S E R V I C E N O T E

HP 5DX Structural Process Test Systems Series I, II and 2L.

Potential X-Ray Emission

Serial Numbers: USXXXXXX114 / USXXXXXX430

Figure 4. 5DX Series I with Bracket (wb)

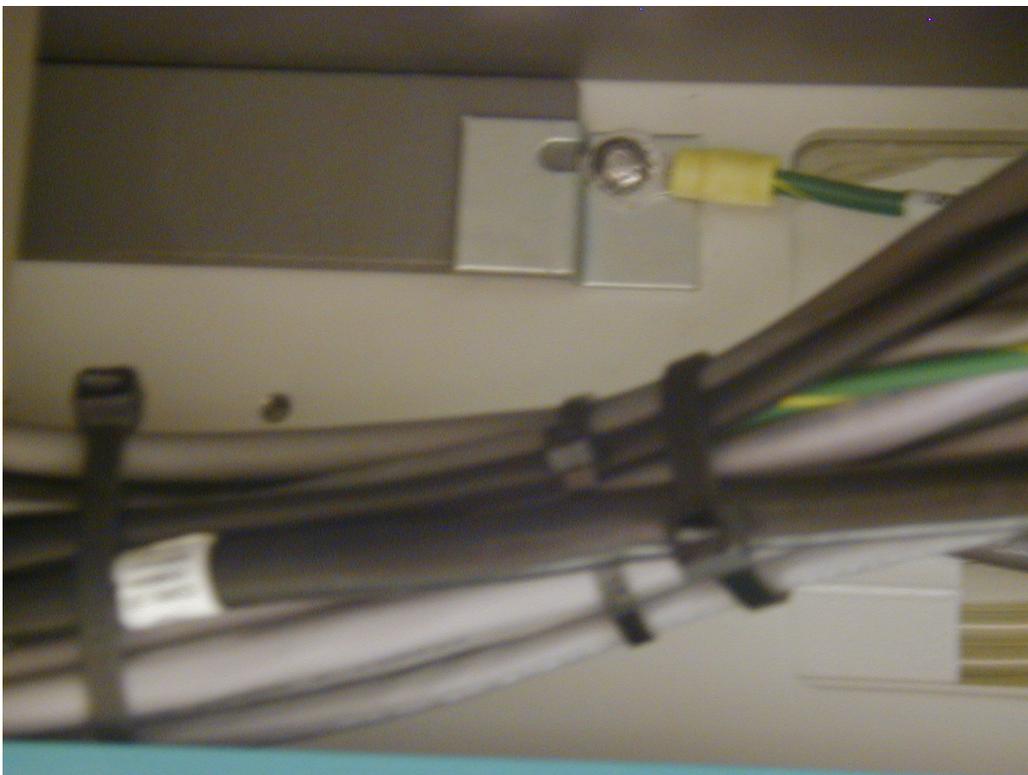
A lead shield mounted on the outside of the 5DX is gravitating down. This creates a potential for an X-Ray Radiation emission.

The Agilent spec is .150 mR/hr; the US CDRH spec is .500 mR/hr. The Japan Government spec is .179mR/hr. The lead shield E7200-27902 (on 5DX Series I and II's) and part number E7200-01242 (on 5DX Series 2L's) is cantilevered causing it to gravitate downward.

Implement this service note before doing X-Ray Survey. Add bracket to hold lead shield in place.

1. Locate lead shield. Lead shield is located by the cable access, at the left rear corner of the 5DX, as viewed from the front of the 5DX. Look behind the blue metal skirt. The lead shield is .2" (.51 cm) thick and 1.25" (3.18 cm) wide.
2. Remove screw securing ground strap at the end of lead shield.
3. Install bracket and replace ground strap with Safety screw.
